Maitland to Minimbah Third Track Project Submissions Report Including Preferred Project Report September 2010

Australian Rail Track Corporation

Submissions Report including Preferred Project Report

H8R-REP-S2G-ENV-0019-0

Figure 5.1

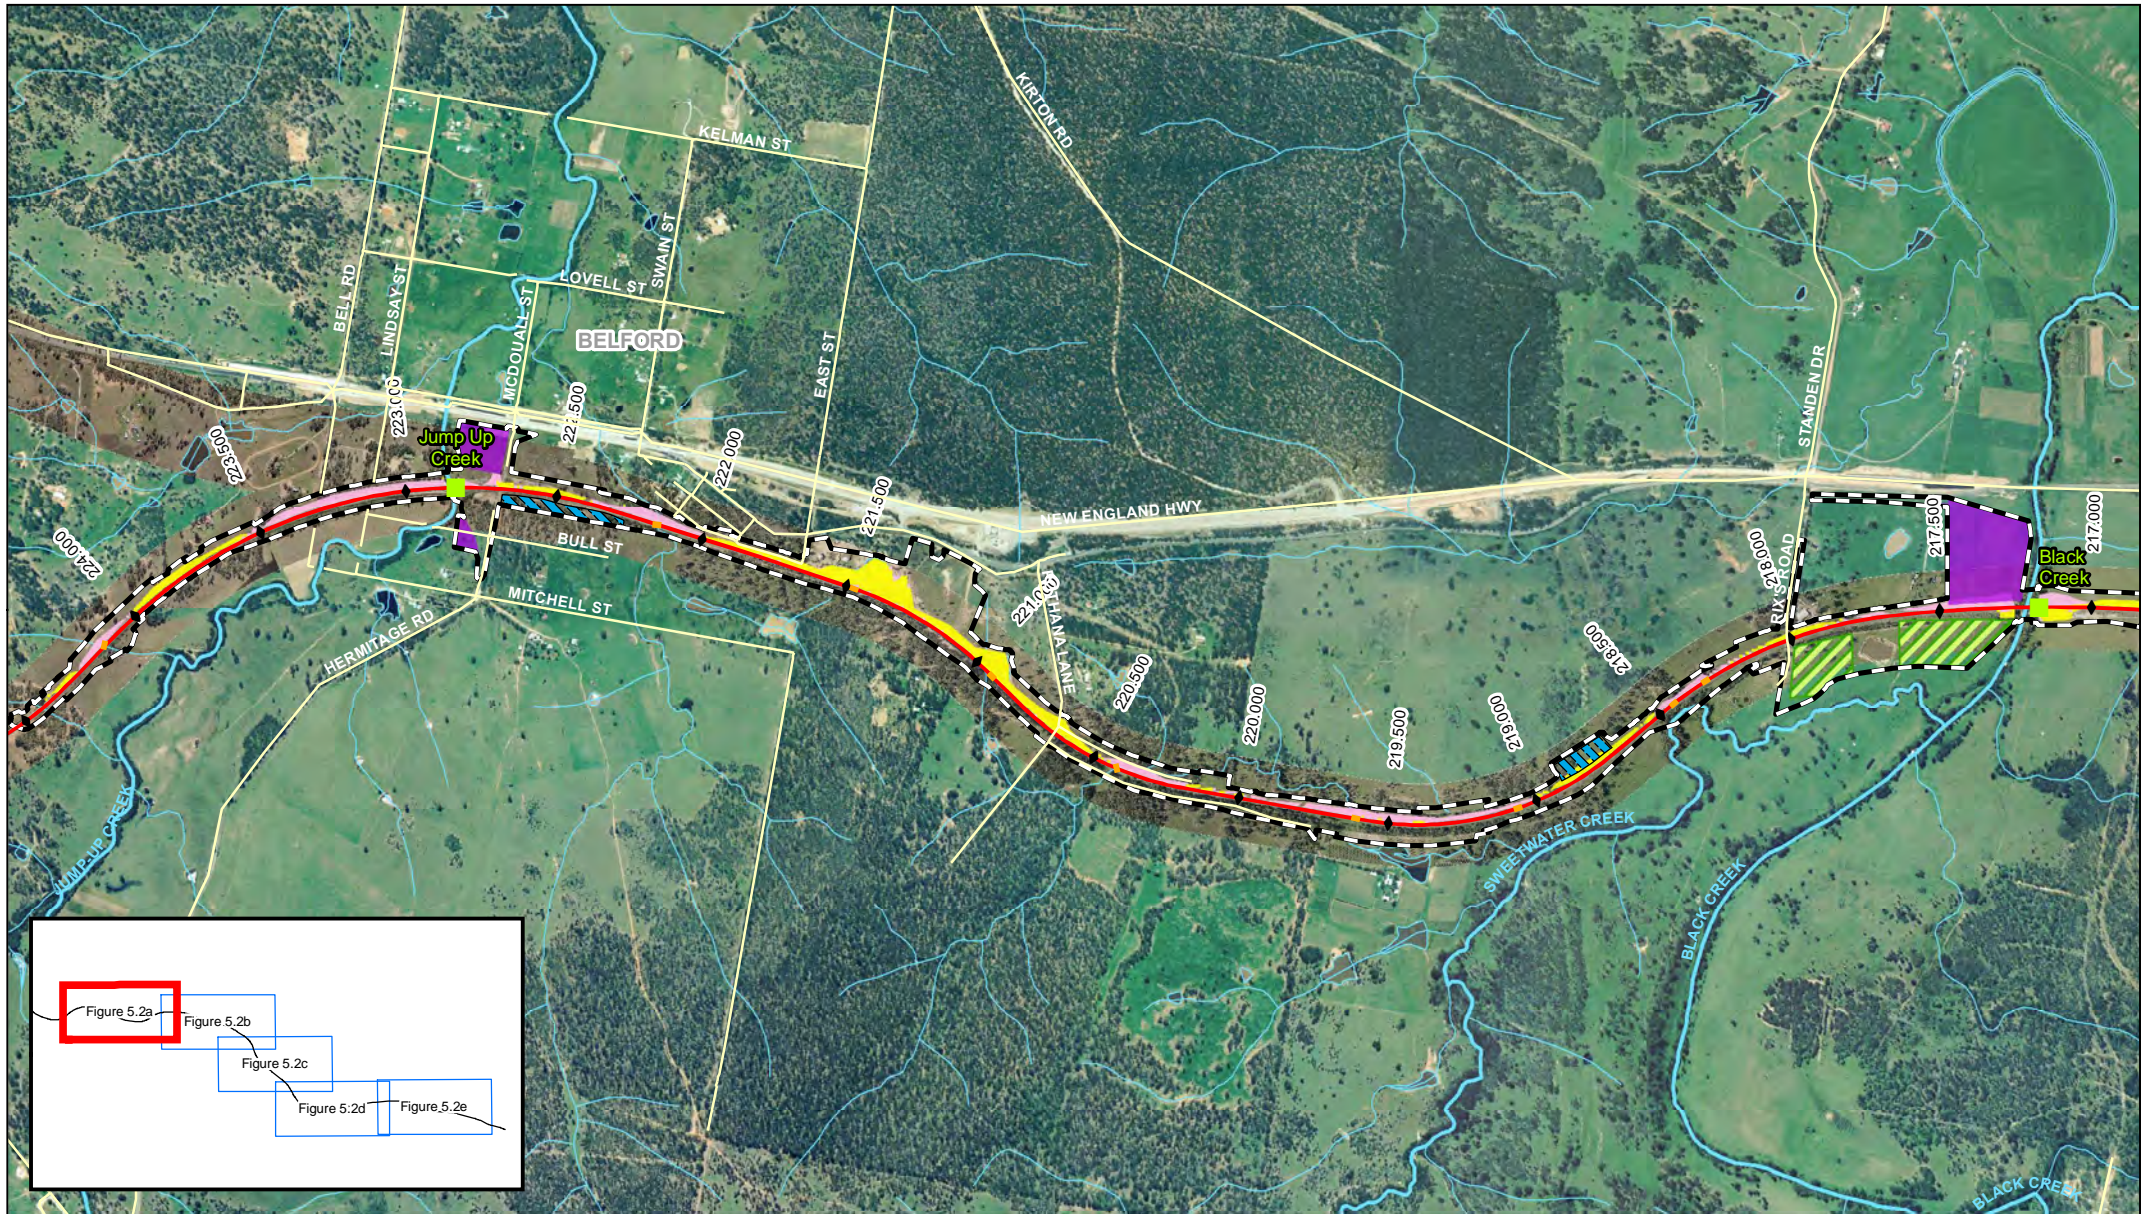
Table 5-2 provides a detailed summary of the proposed modifications to the Project from that described in Chapter 7 of the Environmental Assessment. Figure 5.1 shows the revised Project layout, while Figure 5.2 displays the revised Project description. Revised design drawings are provided in Appendix G.

Figure 5.2a

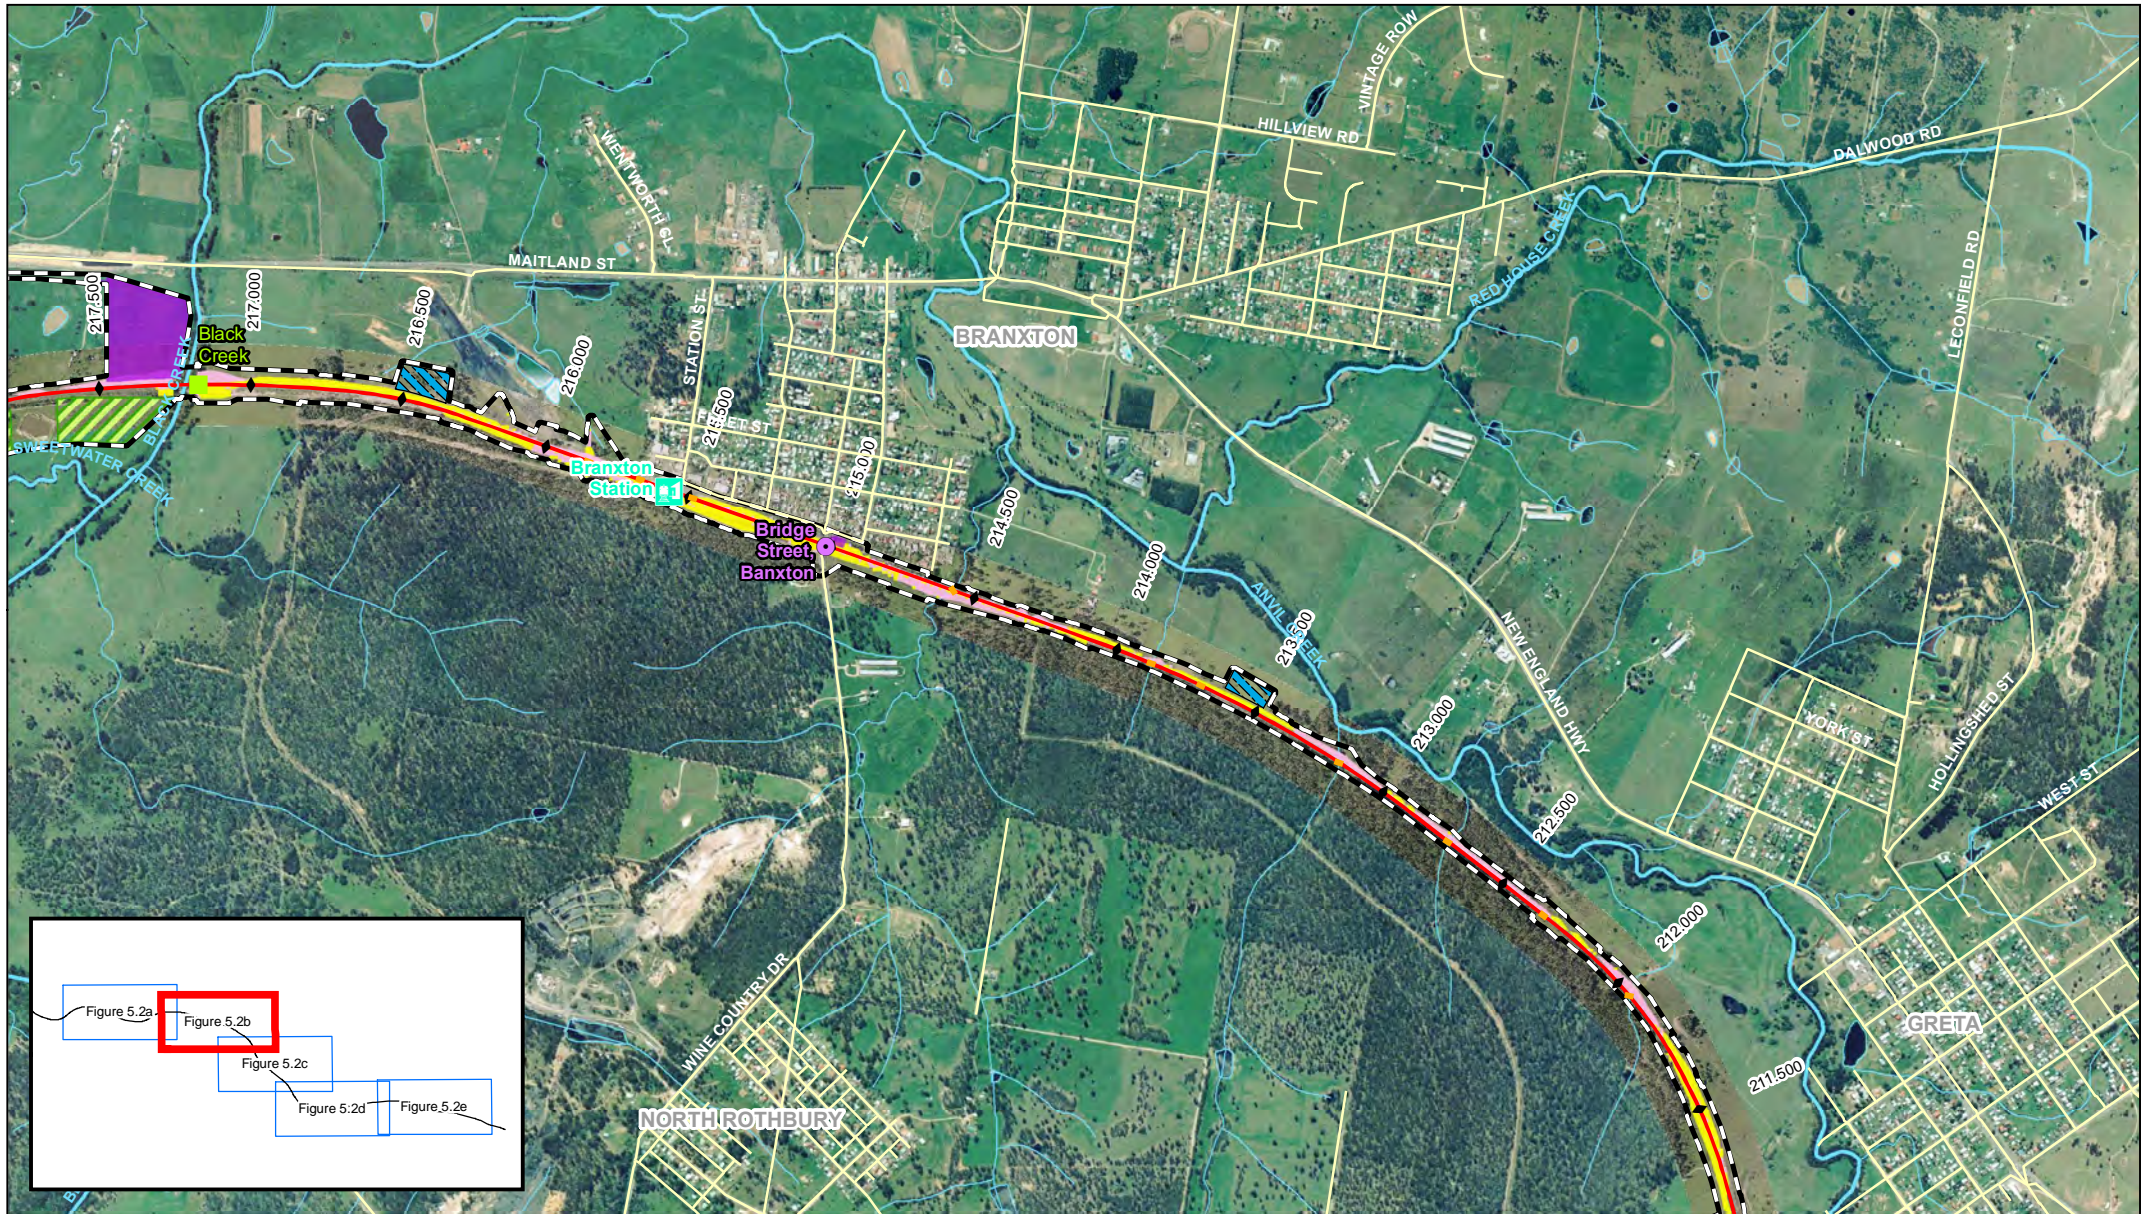
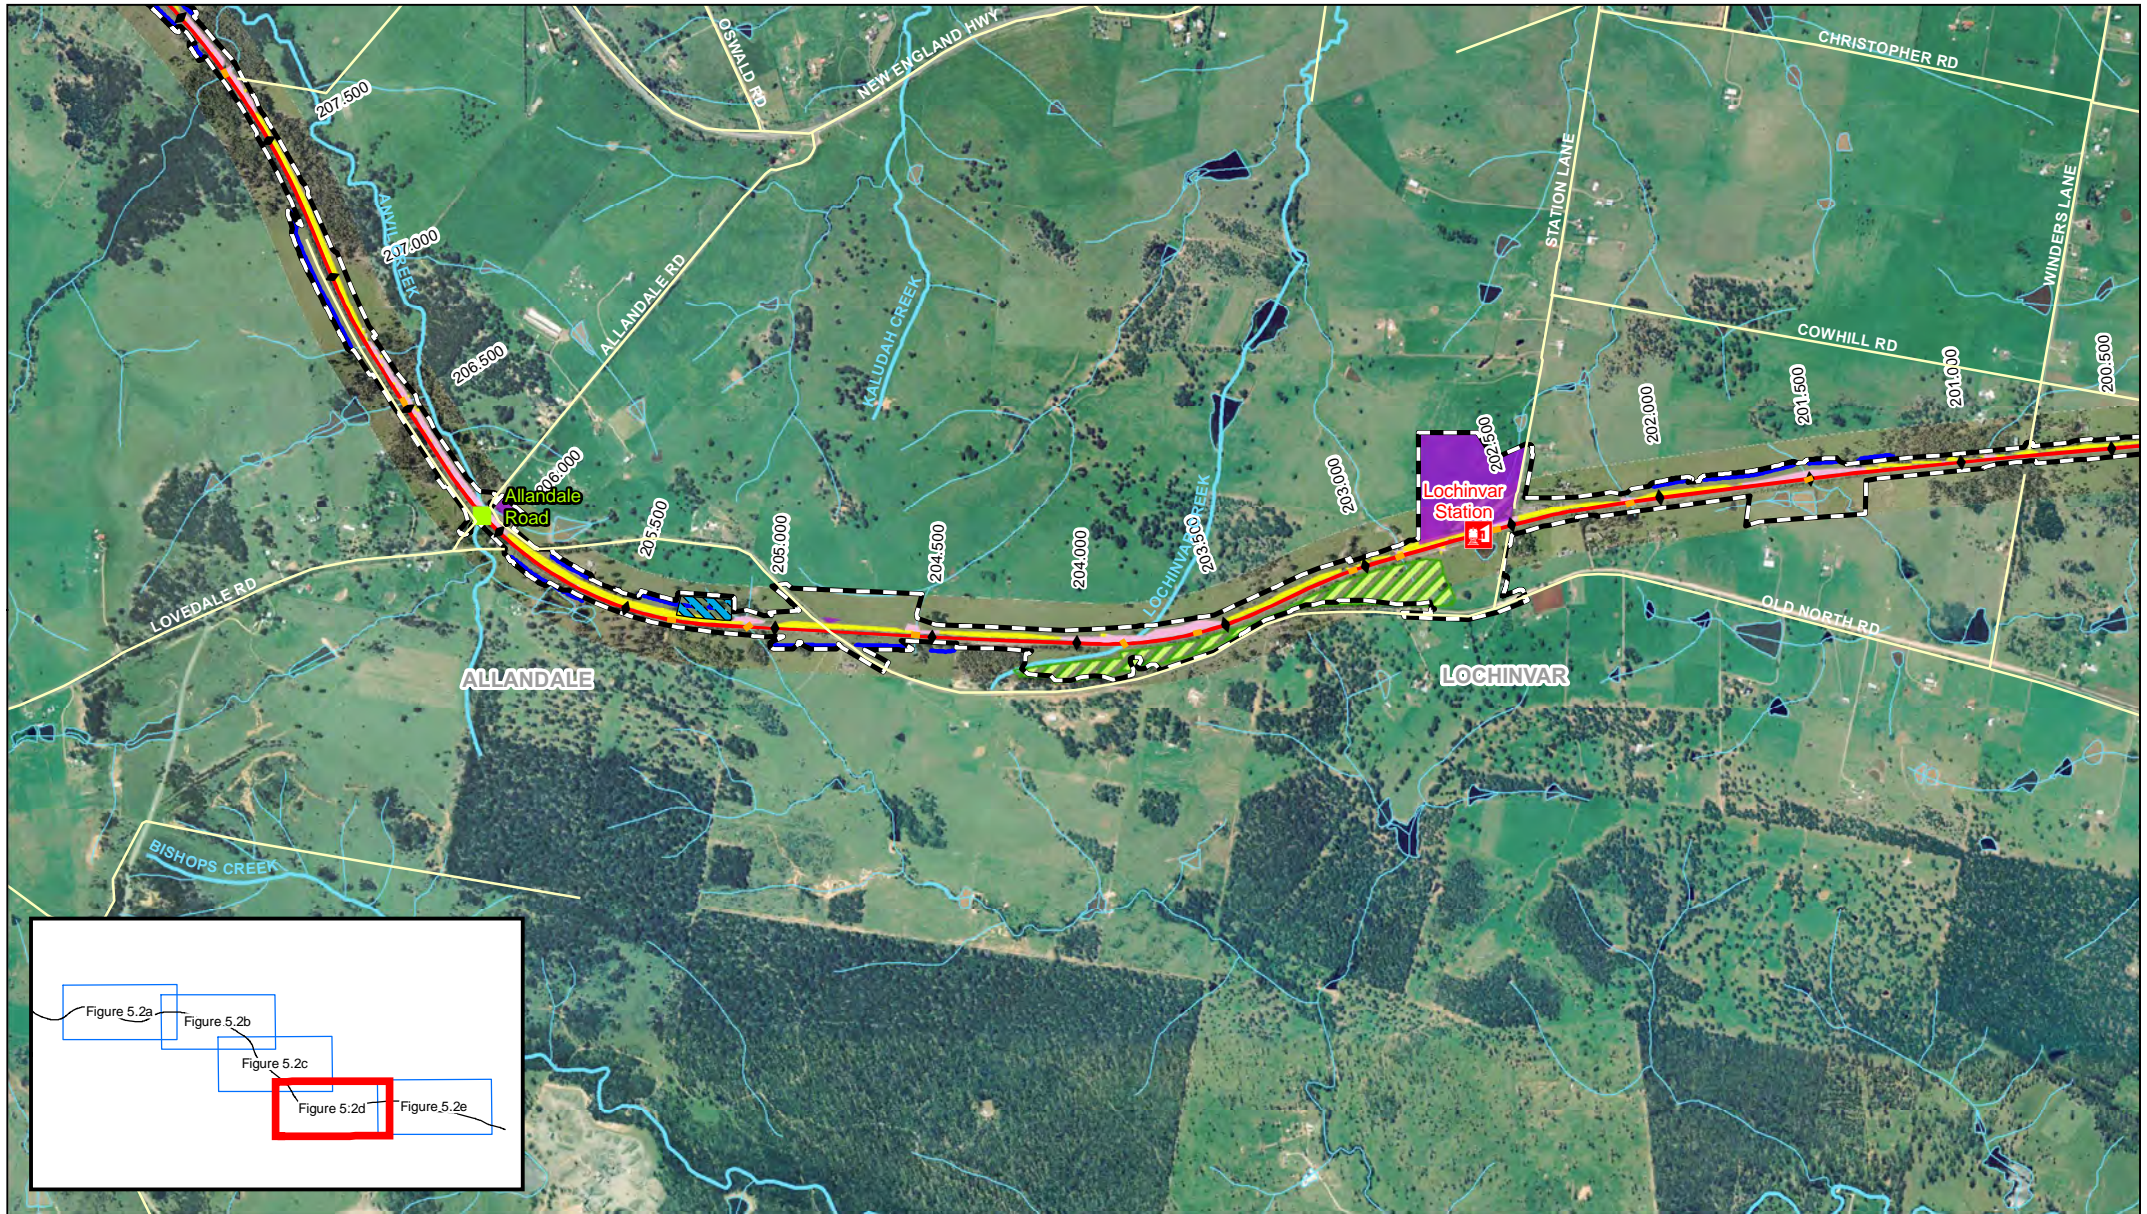
Potential spoil area locations are identified in Table 5-6 and shown in Figure 5.2.

The locations of these compounds are shown in Figure 5.2.

Figure 5.3 Typical Cross Section – Fill

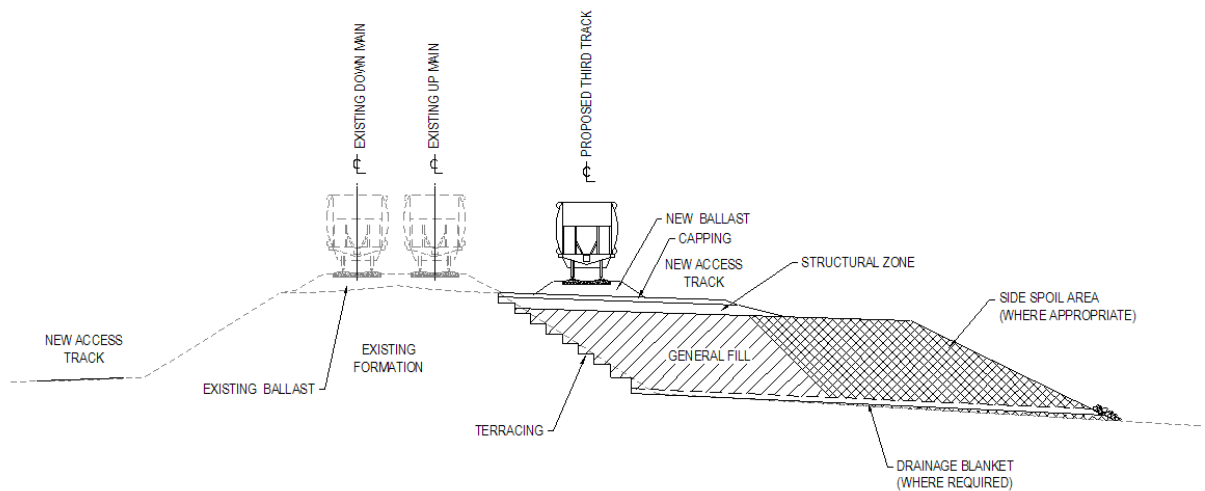
Earthworks required for the Project have been amended from that provided in Section 7.9 of the Environmental Assessment due to the following:

- ▶ Reduction in track centres and changes to the drainage between the tracks (as discussed in Sections 5.2 and 5.5).
- ▶ Minimising earthworks required for the proposed Down side access track (as discussed in Section 5.2).

Typical cross sections illustrating the revised cut and fill earthworks scenarios are illustrated in Figure 5.3 and Figure 5.4.

Figure 5.5 Typical Drainage Arrangement Cross Section

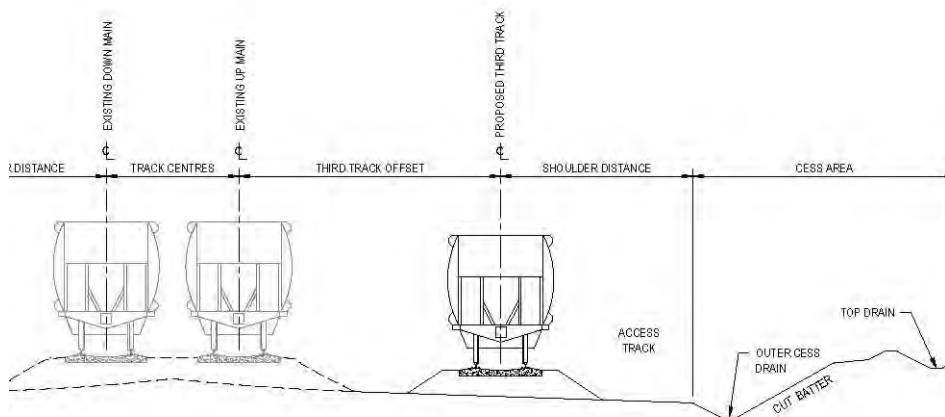
Track and cess drainage has been revised from that provided in Section 7.13 of the Environmental Assessment. Figure 5.5 provides a cross section of the typical components of the proposed track and cess drainage revisions.
